Product Change Notification

PCN25-29_A Switch Lock-Shorting contacts versions

C&K

2. Overview

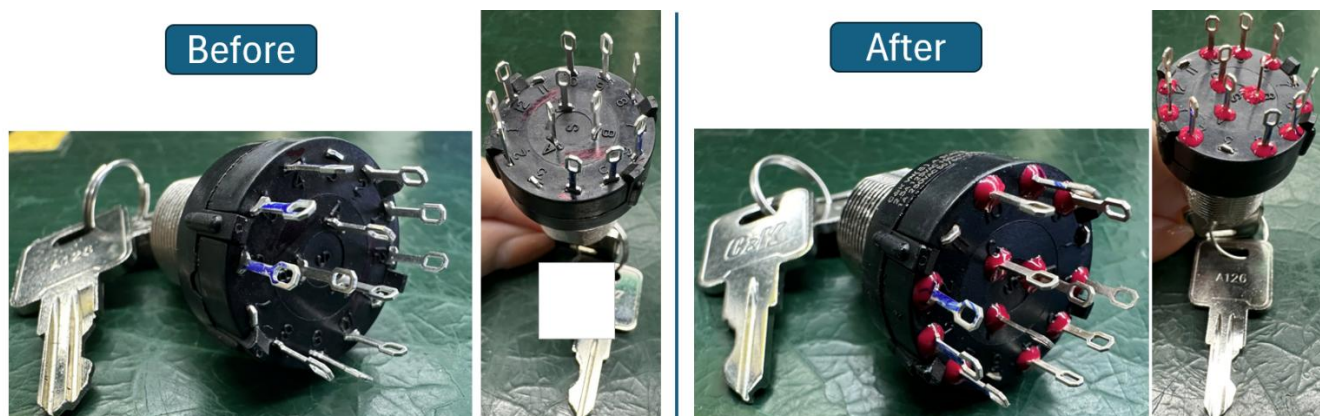
As part of improvement action, epoxy resin is added on terminals of “A Switch Lock” switches featuring “Shorting contacts” option.

An analysis conducted by C&K showed during actuation of the switch that there was a slight movement of the terminals.

To eliminate this movement and avoid risk of bouncing during the actuation, epoxy is added to stabilize the terminals in the housing.

This action will improve the shorting / MBB (Make-before-break) function of the switch.
